**City of Portland, Maine – Building or Use Permit Application** 389 Congress Street, 04101, Tel: (207) 874-8703, FAX: 874-8716

Location of Construction: 10 Island Ave. Peaks 04108		Owner: James Soley		Phone: 775-2252		Permit No: <b>991059</b>	
Owner Address: 10 Island Ave. Peaks 04108		Lessee/Buyer's Name:		Phone:		BusinessName:	
Contractor Name: Self		Address:		Phone:		Permit Issued: <b>SEP 28 1999</b>	
Past Use: Single Family		Proposed Use: Same		COST OF WORK: \$4,260.00		PERMIT FEE: \$54.00	
				FIRE DEPT. <input type="checkbox"/> Approved <input type="checkbox"/> Denied		INSPECTION: Use Group: <i>A3</i> Type: <i>5B</i>	
Proposed Project Description: Construct deck w/Greenhouse		Signature:		Signature: <i>[Signature]</i>		Zone: CBL: 034-R-008	
		PEDESTRIAN ACTIVITIES DISTRICT (P.A.D.)		Action: <input type="checkbox"/> Approved <input type="checkbox"/> Approved with Conditions <input type="checkbox"/> Denied		Zoning Approval: <i>01-2927/99</i> Special Zone or Reviews: <input type="checkbox"/> Shoreland <input type="checkbox"/> Wetland <input type="checkbox"/> Flood Zone <input type="checkbox"/> Subdivision <input type="checkbox"/> Site Plan maj <input type="checkbox"/> minor <in

10 ISLAND AVE, PEARLS IS.  
 JAMES J. SOLEY  
 GREENHOUSE ADDITION (KIT)  
 ~88 SQ. FT.

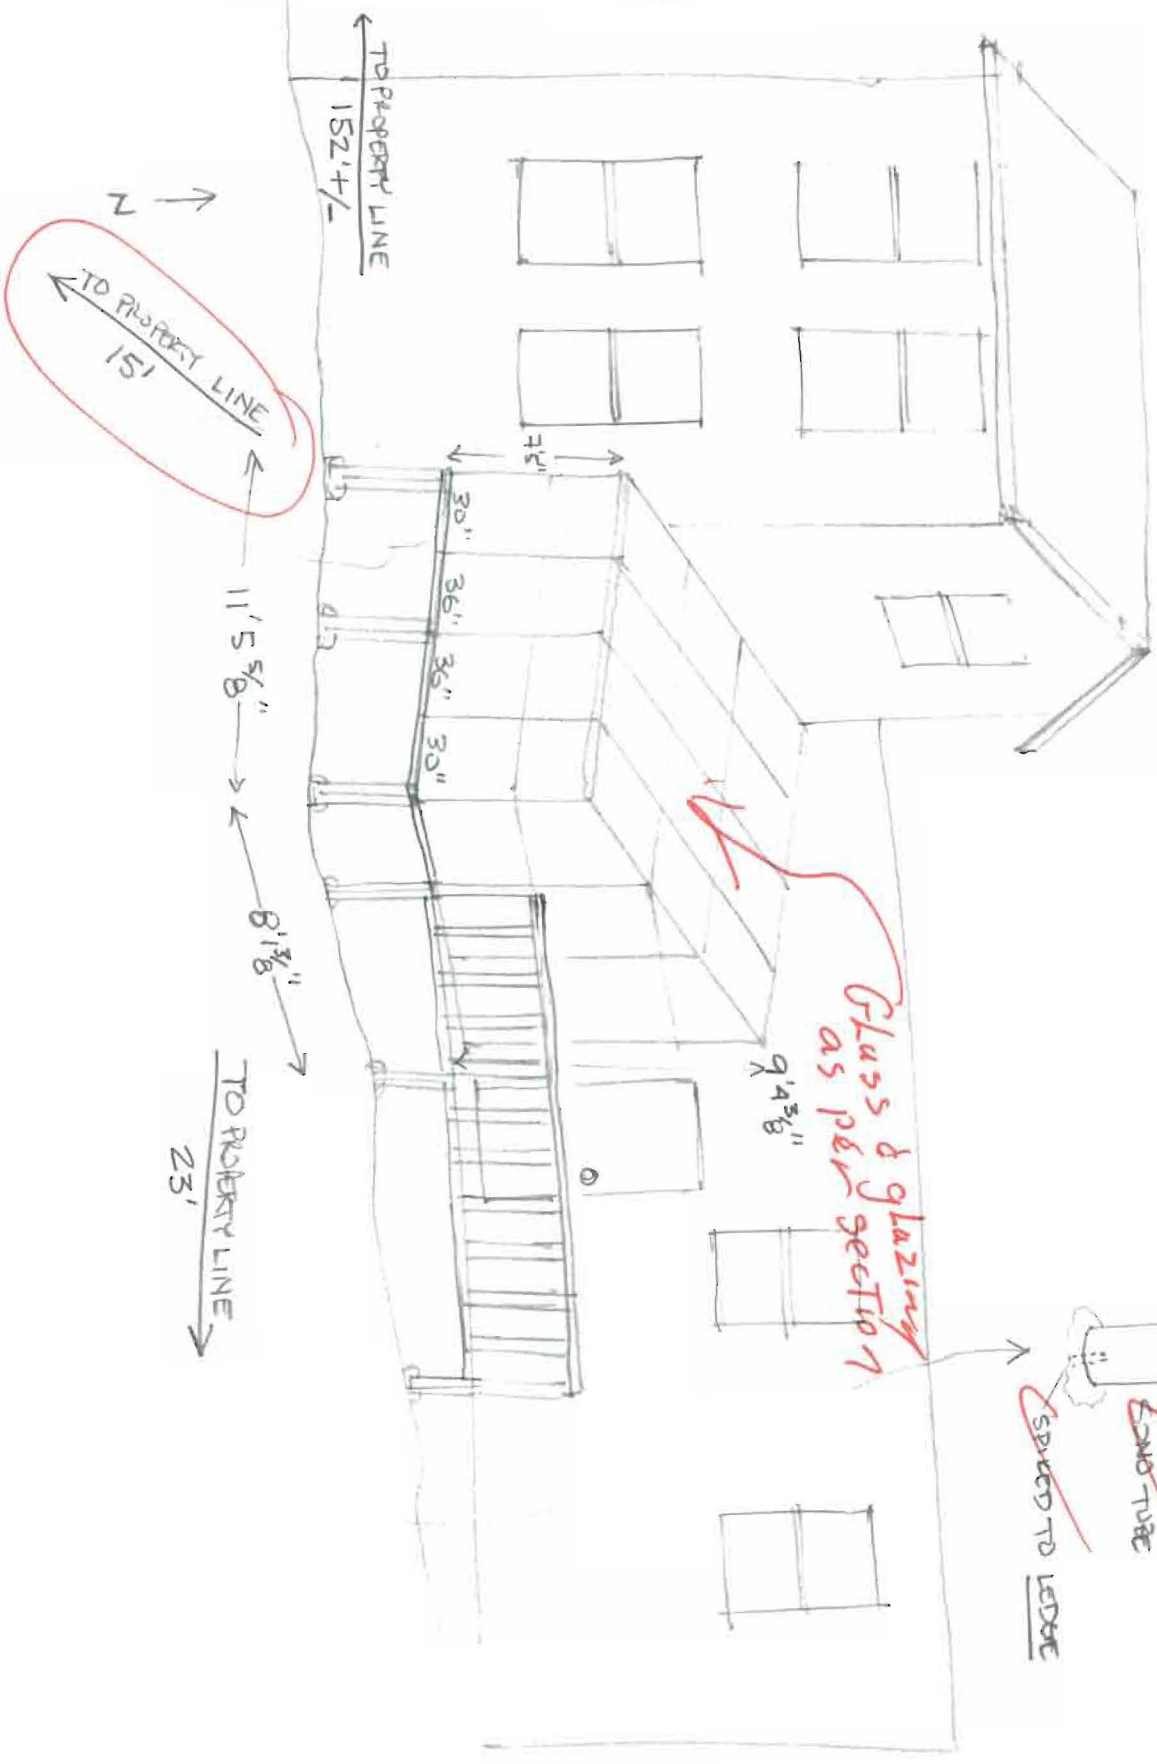
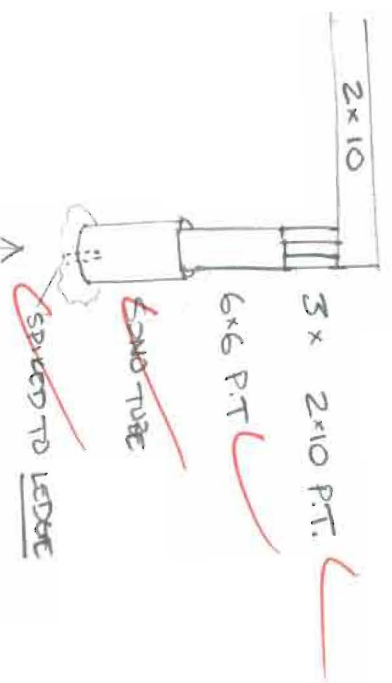
Front 20' req - 23' show  
(or average)

rear - 10' req - 100' show

side 10' req - 15' show
